2020 Ford Truck Ranger 4WD L4-2.3L Turbo
Vehicle > Technical Service Bulletins

SEAT PAN LOOSENESS, LATERAL MOVEMENT, OR CLUNK/THUMP NOISE ON TURNS

22-2104
18 March 2022

This bulletin supersedes 21-2236.

Figure 1

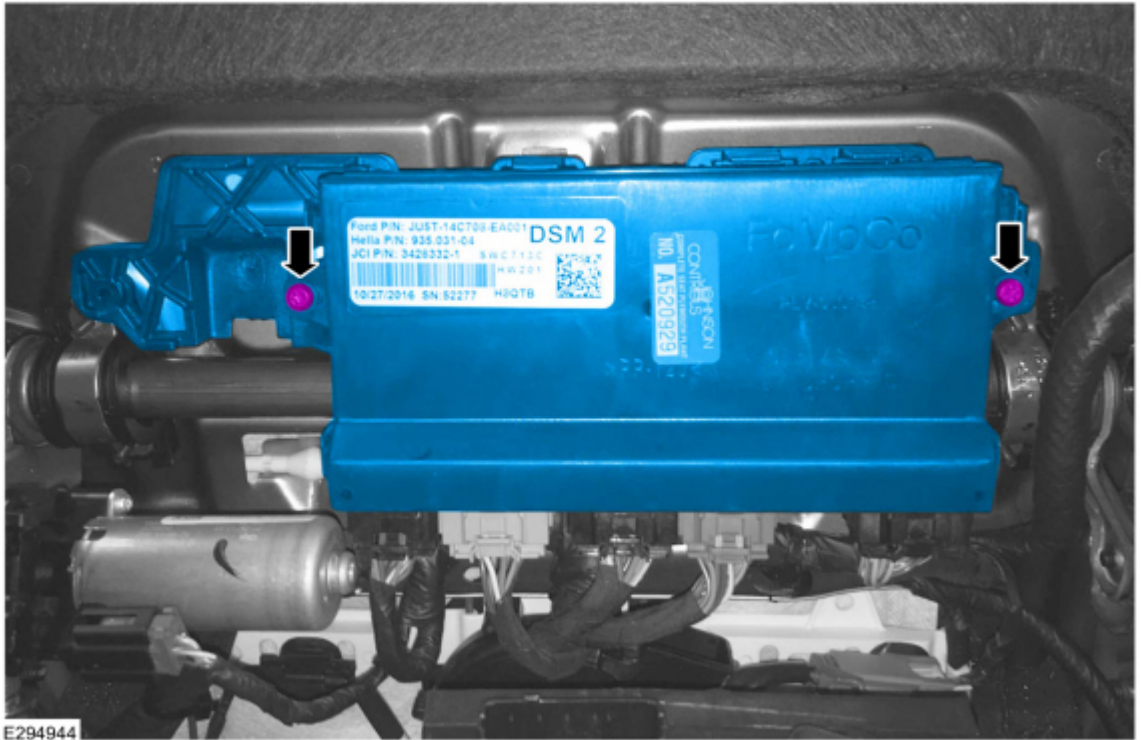
4. Is the vehicle equipped with a power seat control module under the seat? (Figure 1)

(1). Yes - remove the 2 power seat control module retaining screws and remove the power seat control module.

Figure 2

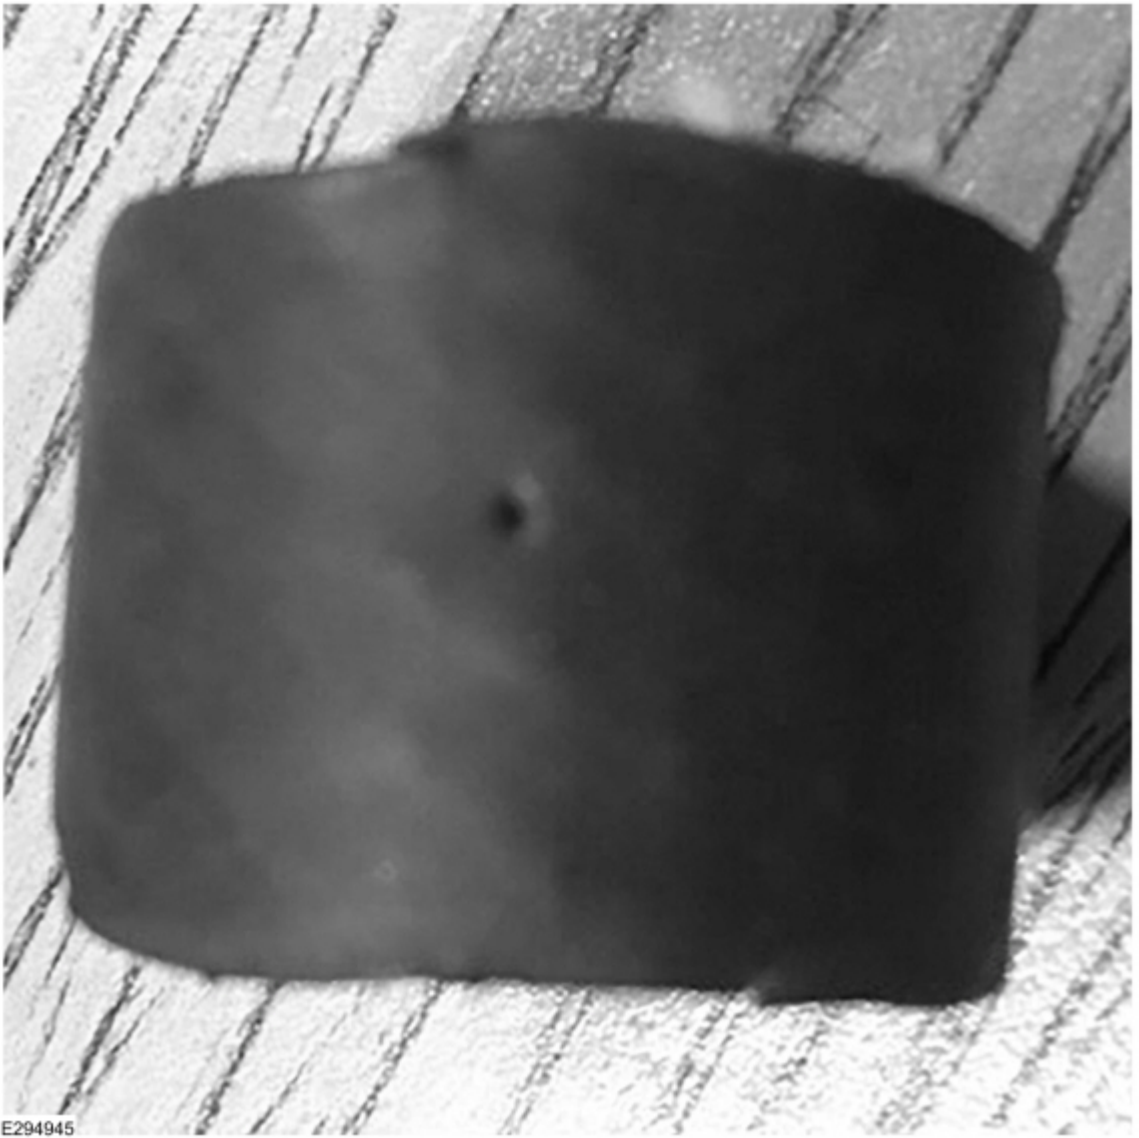
5. Cut a 1 inch (25.4 mm) long section of 3/4 inch (19 mm) diameter heater hose. (Figure 2)

Figure 4

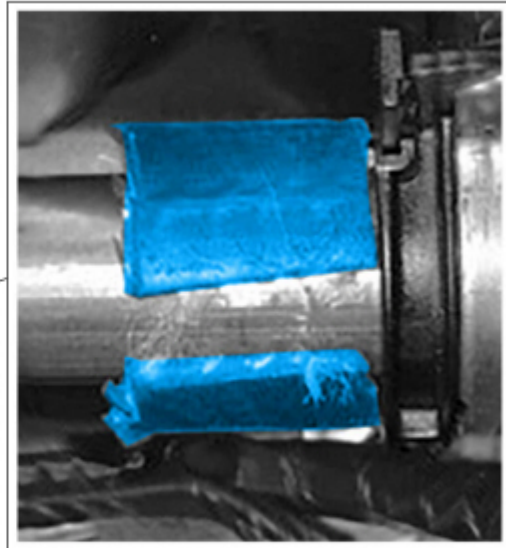
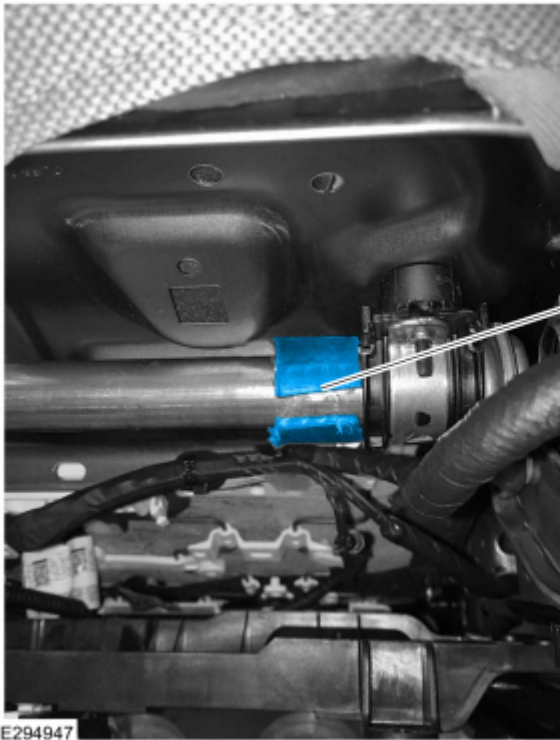
7. Install the heater hose over the front cross tube. (Figure 4)

Figure 5

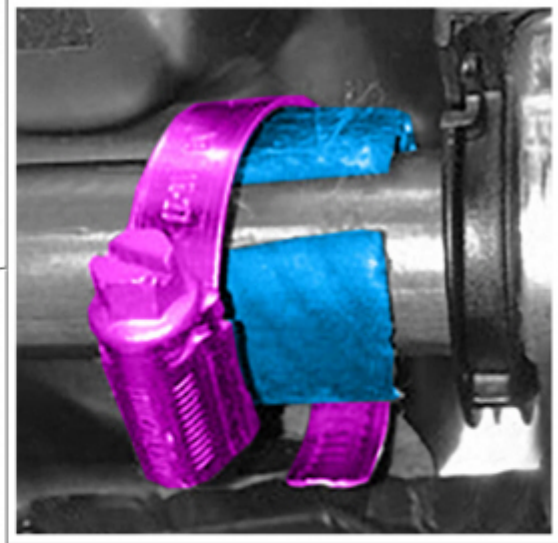
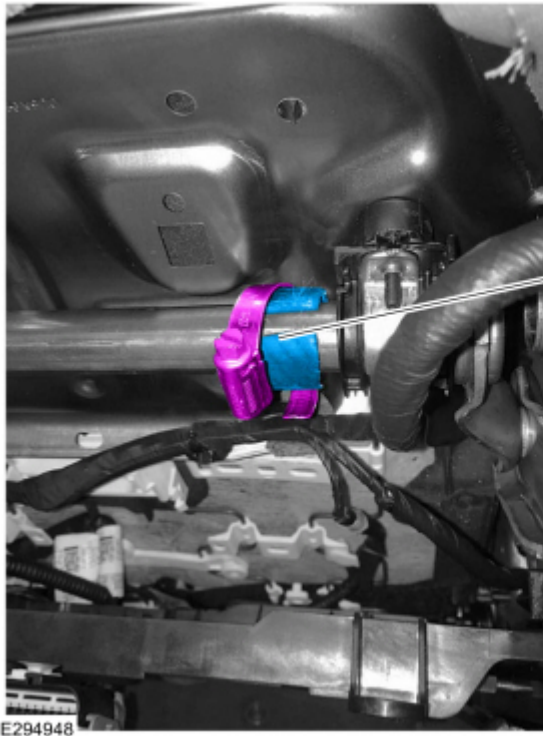
8. Open the hose clamp and slip the hose clamp over the heater hose, securing the heater hose to the front cross tube. (Figure 5)

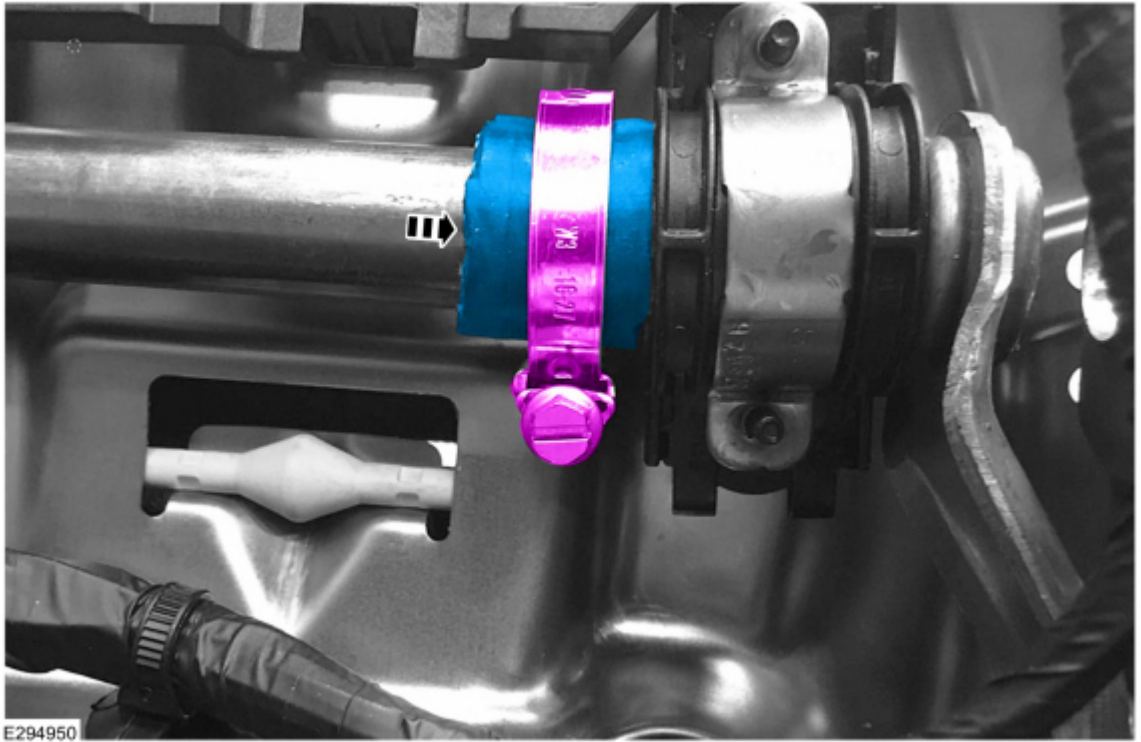
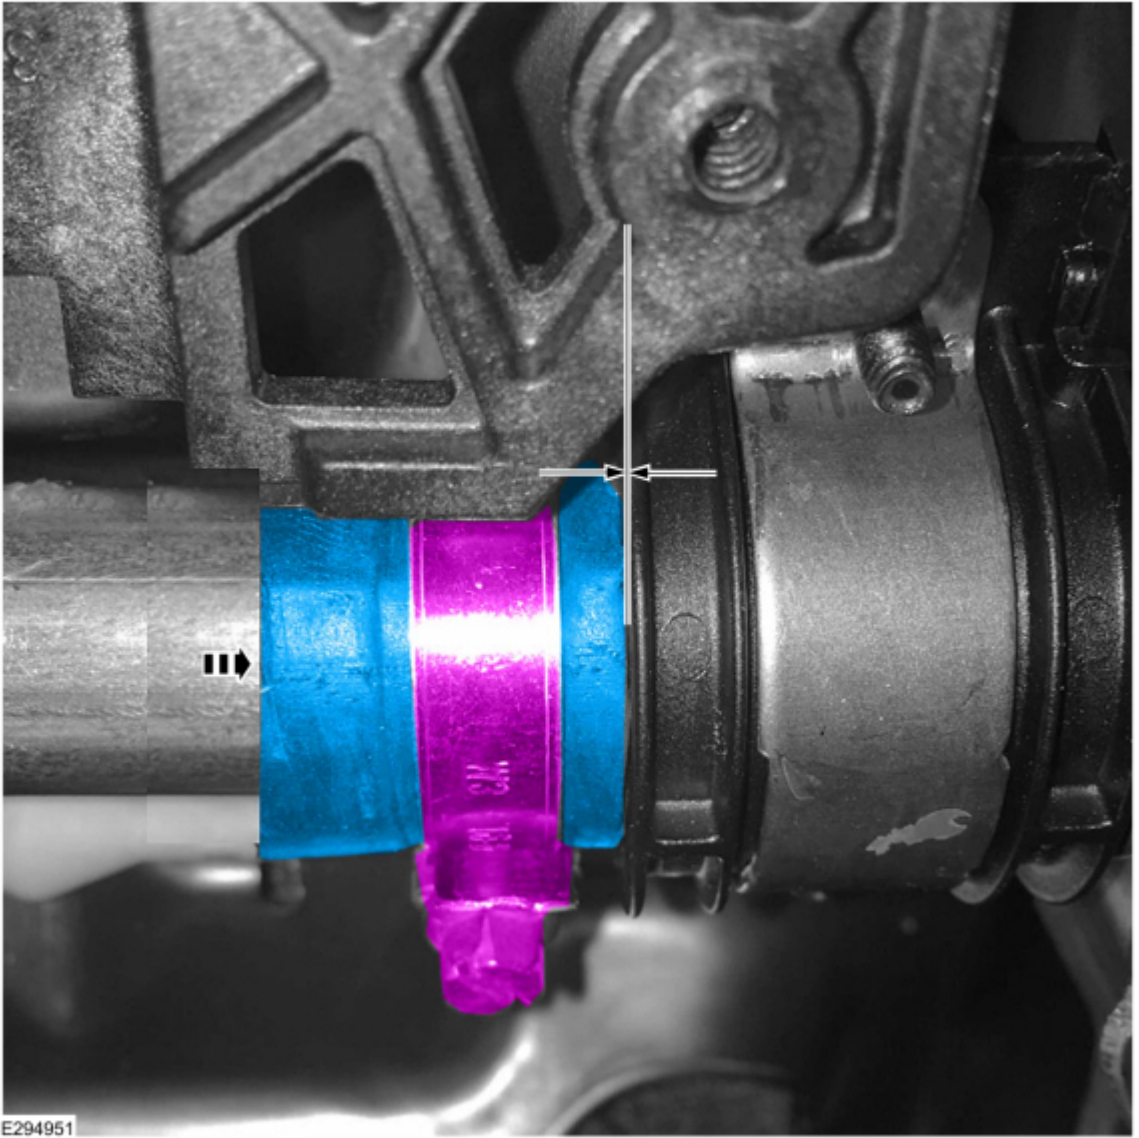
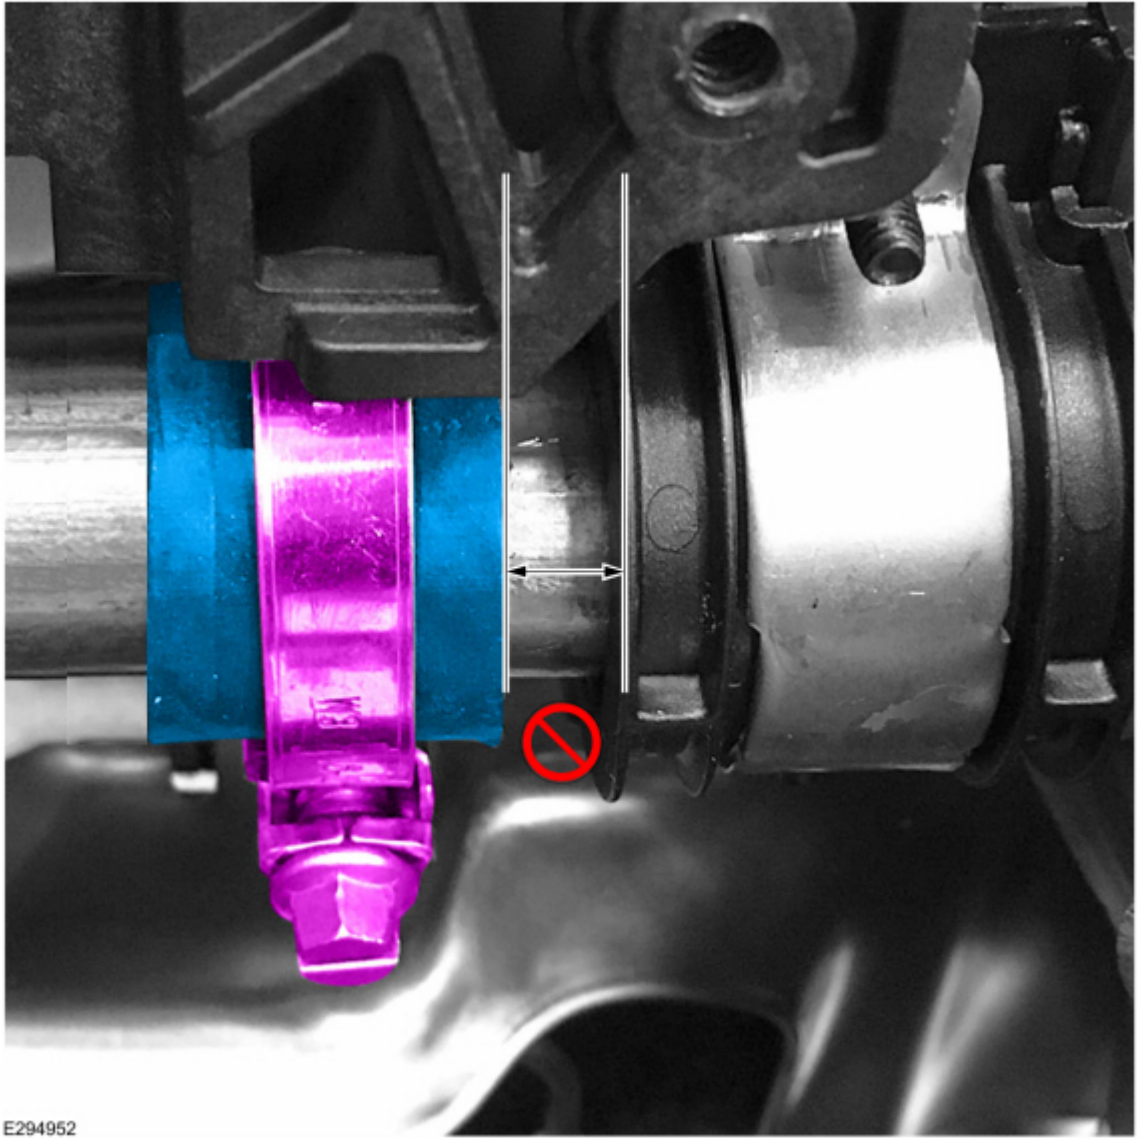
9. Push the heater hose against the handcuff bracket and tighten the hose clamp to 3.7 Nm (33 in-lbs).
(Figures 6-9) Refer to Figures 6-7 for clamp orientation.
